Ventura County Community College District

DATE: November 5th, 2024
TO: All Bidders
FROM: Spencer Herson, Purchasing Specialist
SUBJECT: Addendum 1 – Bid 694, Ventura College Annex Modernization

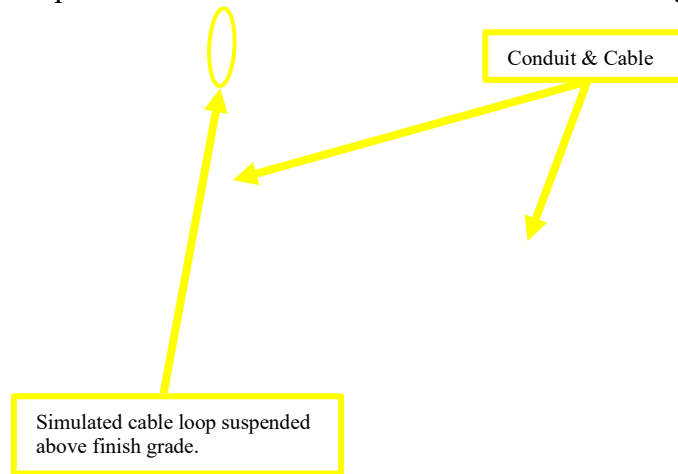
7. Need clarification on scope of work under 3.3 13, 3.3 14, and 3.3 15. It is not clear if it is data or power. Are there any more details available?

RESPONSE: In the images below, you can see the pole, the conduit, and the cabling inside the conduit noted in Items 3.3.13/14/15. The cable is to be pulled from inside the building, out of the conduit and hung via a pole mounted hangar on this pole. The base of the loop of the cable shall be not less than 15' above finish grade. The conduit shall be removed, disposed, and all holes/penetrations sealed on the exterior of the building.
